Greater Dublin Drainage Project Addendum

Appendix A14.3 – Response to Air Quality and Odour Questions at the 2019 Oral Hearing

Response to Air Quality and Odour Questions

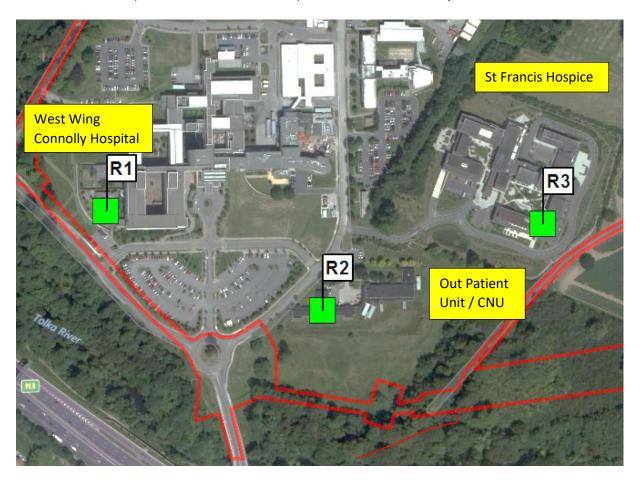
- (2) The Inspector has requested that information be provided about the assessment of impact on St Francis Hospice. An extract from Figure 14.4 is shown below to indicate where the Hospice is relative to Connolly Hospital and the elements of the proposed Project.

- (3) The construction phase air quality impact on St Francis Hospice is assessed in section 14.5.1 and section 14.5.2 of the EIAR. Air quality monitoring for baseline assessment was carried out at the Hospice (Tables 14.7 and 14.8, AQ1) and this sensitive receptor was included as R3 in the impact assessment. The main potential construction phase impact is dust and particulate matter as identified in the EIAR. The receptor sensitivity in the immediate vicinity of the proposed Abbotstown pumping station site is high because of the proximity of residential receptors, Connolly Hospital and St. Francis' Hospice.

- (4) All construction works on the grounds of and in the immediate vicinity of Connolly Hospital and St. Francis' Hospice will be carried out in accordance with the requirements of the *National Guidelines for the Prevention of Nosocomial Aspergillosis During Construction/Renovation Activities* (Health Protection Surveillance Centre 2018). These Guidelines note that the fundamental requirements in respect of eliminating Aspergillus infection from construction works is, first, to minimise the dust generated during construction and, second, to prevent dust infiltration into patient care areas.

- (5) The construction phase impact assessment for the Hospice found that there is predicted to be a short-term Slight adverse impact on the closest receptors during the Construction Phase. There will be no lasting impact and the short-term impact will be managed by means of an effective Construction Environmental Management Plan (CEMP) incorporating the mitigation measures outlined in Section 14.8. The CEMP will include a specific Dust Minimisation Plan which will ensure that dust impacts are prevented or minimised during the Construction Phase of the Proposed Project.

- (6) The Operational Phase impact assessment for Connolly Hospital and St Francis Hospice is presented in section 14.6 of the EIAR. This assessment found that all predicted impacts are significantly lower than the levels permissible by the relevant Air Quality Standards and assessment criteria adopted for the project.

- (7) Specifically for odour, the assessment was focused on demonstrating that odour emissions from the proposed Abbottstown Pumping Station would not cause odour nuisance. This criterion was applied at the site boundary and as an additional check, the predicted impact at the Hospital and the Hospice, and at other sensitive receptors, was also assessed. The maximum potential impact at the closest Hospice location is presented in Table 14.38 where it is clear that the predictions are significantly lower than any of the Air Quality Standards or Guidelines referenced in the EIAR. Additional information is presented in Appendix 14.5 and is discussed further below.
